# **Transitional Programme - Newtown to city accessibility audit**

Final

**Prepared for:** Wellington City Council

**Prepared by:** MRCagney (NZ) Ltd, Auckland, New Zealand

**Figure 18 Excerpt from plan - Cambridge Terrace / Vivian Street / Kent Terrace / Pirie Street intersection (C301A)**

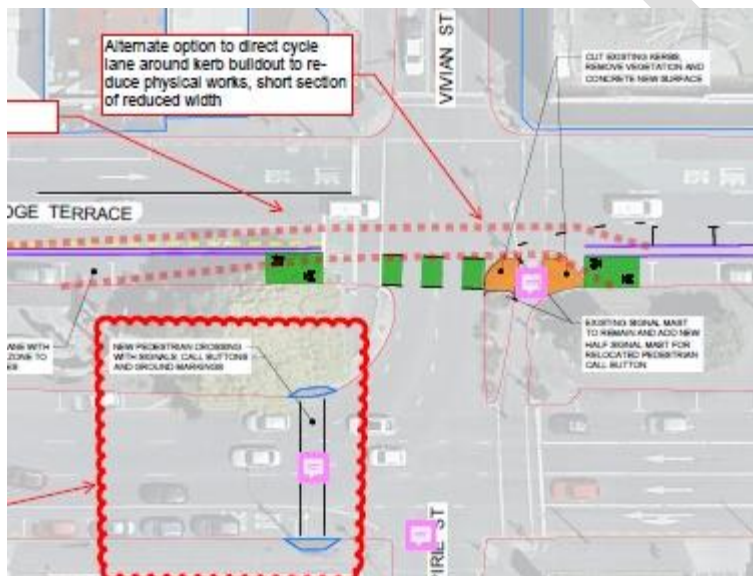
Cycle lane across pedestrian crosswalk: The design shows the cycle lane passing through the signalised pedestrian crossing creating a potential conflict between cyclists and pedestrians.

Signalised cycle phase: Provision of a signalised cycle phase across Cambridge and Kent Terrace to provide access on and off the shared path is recommended.

New pedestrian crossing phase: Installation of a pedestrian phase across Kent Terrace is also recommended, to reduce crossing distances for those dependent on priority-controlled crossings and reduce crossing phases from four to two. This would also assist cyclists accessing the shared path cycle lane from Kent Terrace and Pirie Street.

<b>Cycle lane across pedestrian crosswalk</b>	
<b>Access principle(s):</b>	<b>Safe / Obvious</b>
<b>Overall Rating</b>	<b>Major</b>
<b>Designer response</b>	Will move ped call button back to pedestrian waiting area and phasing will separate out peds and cyclists which removes conflict.
<b>Safety Engineer response</b>	Agree with Auditors and Designer

<b>Cycle lane across pedestrian crosswalk</b>	
<b>Action taken</b>	Designs updated.

<b>Signalised cycle phase</b>	
<b>Access principle(s):</b>	<b>Safe</b>
<b>Overall Rating</b>	<b>Minor</b>
<b>Designer response</b>	Will provide cyclists turning areas for movements into main side streets in 60% designs
<b>Safety Engineer response</b>	Agree with Auditors and Designer.
<b>Action taken</b>	Designs updated.

<b>New pedestrian crossing phase</b>	
<b>Access principle(s):</b>	<b>Safe / Obvious</b>
<b>Overall Rating</b>	<b>Comment</b>
<b>Designer response</b>	Will provide new north/south ped crossing in 60% designs but additional east/west crossing is outside of scope as per earlier client decision
<b>Safety Engineer response</b>	Agree with Designer.
<b>Action taken</b>	No action required, crossing out of scope designs allow for it to be installed in future.

Figure 19 Excerpt from plan - Cambridge Terrace - taxi layover (C302A)

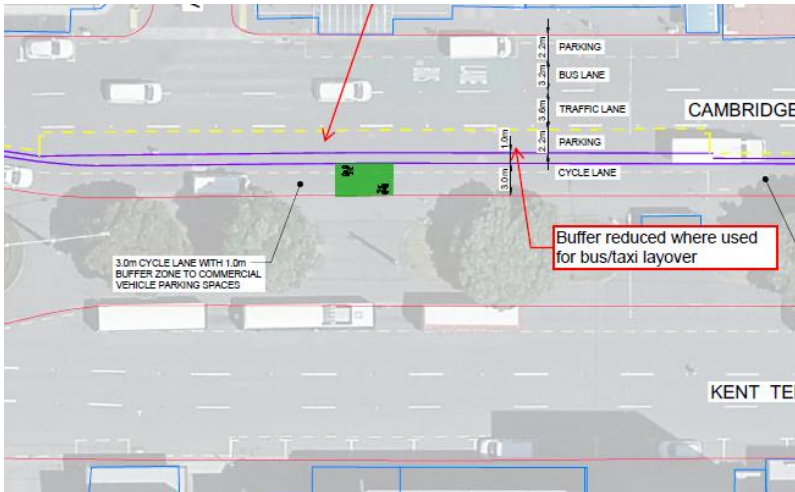
Figure 19 shows the location of an existing taxi layover. It is unclear whether this taxi stand is intended to be accessed by passengers. Safe, obvious and step free access to the taxi stand should be considered as part of the design.

<b>Taxi layover</b>	
<b>Access principle(s):</b>	<b>Safe / Obvious</b>
<b>Overall Rating</b>	<b>Comment</b>
<b>Designer response</b>	Taxi stand to be moved to kerbside
<b>Safety Engineer response</b>	Agree with Auditors and Designer.
<b>Action taken</b>	Taxi stands relocated.

**Figure 20 Excerpt from plan - Cambridge Terrace / Wakefield Street / Oriental Parade intersection (C303A)**

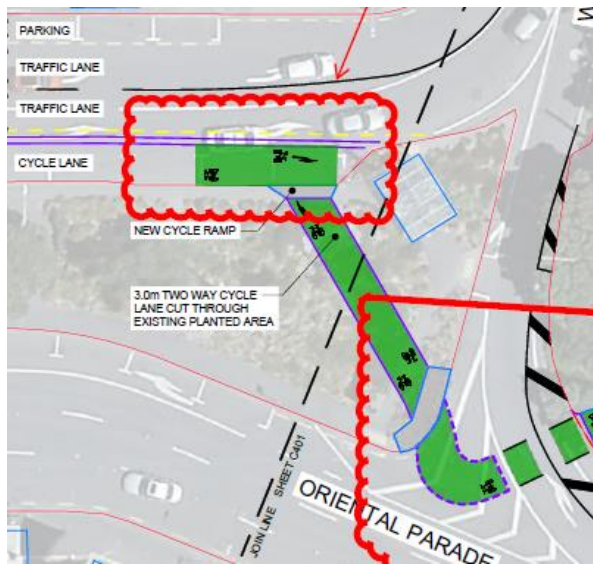
Figure 20 shows the existing layout of non-priority pedestrian crossings across Cambridge Terrace, Kent Terrace and Wakefield Street. Consideration should be given to whether these crossings should be priority controlled. The existing slip lanes do not encourage slower vehicle speeds so there is collision risk between pedestrians and motor vehicle traffic.

Figure 20 shows the end of Cambridge Terrace leading onto Wakefield Street, and Oriental Parade leading into Kent Terrace. With the split in roads, it is not obvious where the cycle lane goes without provision of advanced wayfinding signage.

Figure 20 shows the end of the cycle lane diverting to the right to line up with crossing the Wakefield Street slip lane. It is understood that there is an existing footpath that intersects this proposed cycle lane. Priority across the footpath is unclear from the design.

Further consideration into the design of the proposed cycle lane crossing across the Oriental Parade / Wakefield Street slip lane is recommended to provide a safe and obvious route.

Non-priority pedestrian crossings	
Access principle(s):	Safe / Obvious
Overall Rating	Major
Designer response	Outside of transitional cycleways scope to create new traffic signals due to cost and time involved. Cycle and pedestrian crossing of Wakefield St is subject to further design work
Safety Engineer response	Agree with Designer.
Action taken	Designs update since audit, no longer part of route.

Northbound cycle lane - wayfinding	
Access principle(s):	Safe / Obvious
Overall Rating	Comment
Designer response	Will incorporate this feedback into the signage and wayfinding plan
Safety Engineer response	Agree with Auditors and Designer.

Northbound cycle lane - wayfinding	
<b>Action taken</b>	Designs update since audit, no longer part of route.

Pedestrian / cycle lane conflict	
<b>Access principle(s):</b>	<b>Safe / Obvious</b>
<b>Overall Rating</b>	<b>Major</b>
<b>Designer response</b>	Layout of cycleway in this location has changed in the 60% designs to be on east side of the central island which removes the ped/cycle conflict
<b>Safety Engineer response</b>	Agree with Designer.
<b>Action taken</b>	Designs update since audit, no longer part of route.

Wakefield Street slip lane crossing	
<b>Access principle(s):</b>	<b>Safe / Step Free</b>
<b>Overall Rating</b>	<b>Major</b>
<b>Designer response</b>	Cycle and pedestrian crossing of Wakefield St is subject to further design work with a focus on road safety
<b>Safety Engineer response</b>	Agree with Designer.
<b>Action taken</b>	Designs update since audit, no longer part of route.

Figure 21 Excerpt from plan - Oriental Parade (C401A)

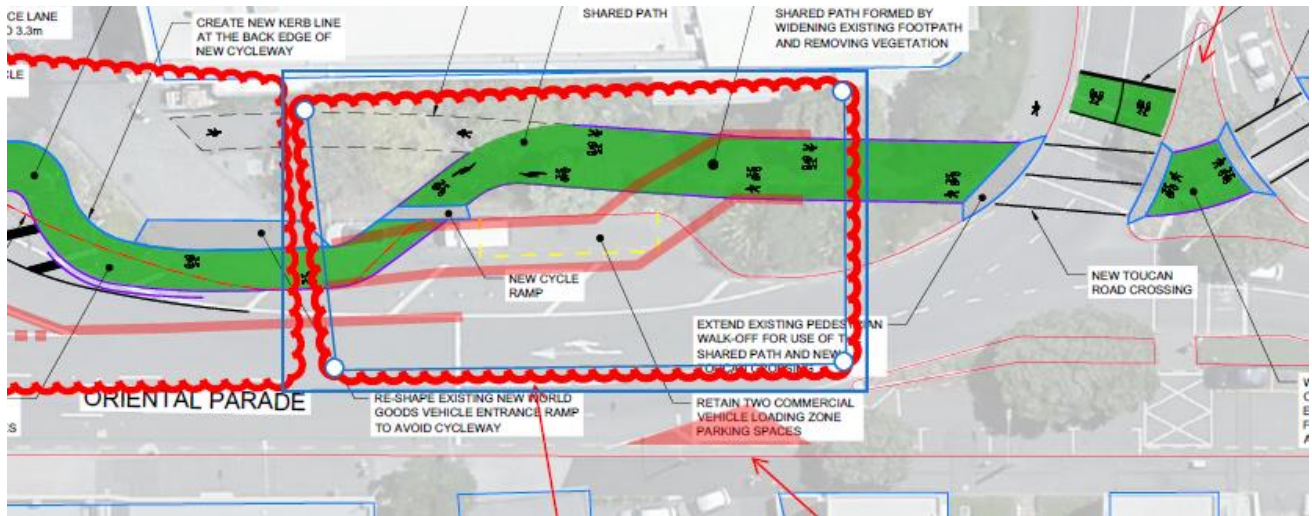
Figure 21 shows the proposed shared path along Oriental Parade merging cyclists and pedestrians. Detectable guidance for visually impaired and vulnerable users is recommended to identify when the path is shared and when it is separated. There is potential for conflict when pedestrians are required to cross the cycle path to return to the footpath. Signage is recommended to inform everyone of potential risks at this location.

Figure 21 shows the existing footpath and proposed cycle path crossing a loading bay for a supermarket. Consideration should be given to improve the loading bay crossing so that everyone is aware of the adjacent

activity. If delivery vehicles are reversing from the loading area more detail is recommended to minimise risk of collision.

Oriental Parade shared path	
Access principle (s):	Safe / Obvious / Step Free
Overall Rating	Major
Designer response	Agree with the accessibility audit to provide guidance to pedestrians
Safety Engineer response	Agree with Auditors and Designer.
Action taken	Designs update since audit, no longer part of route.

Existing footpath / loading bay conflict	
Access principle(s):	Safe / Step Free
Overall Rating	Major
Designer response	Agree that supermarket deliveries operation is an issue, back of New World area is subject to further design work
Safety Engineer response	Agree with Auditors and Designer.
Action taken	Designs update since audit, no longer part of route.
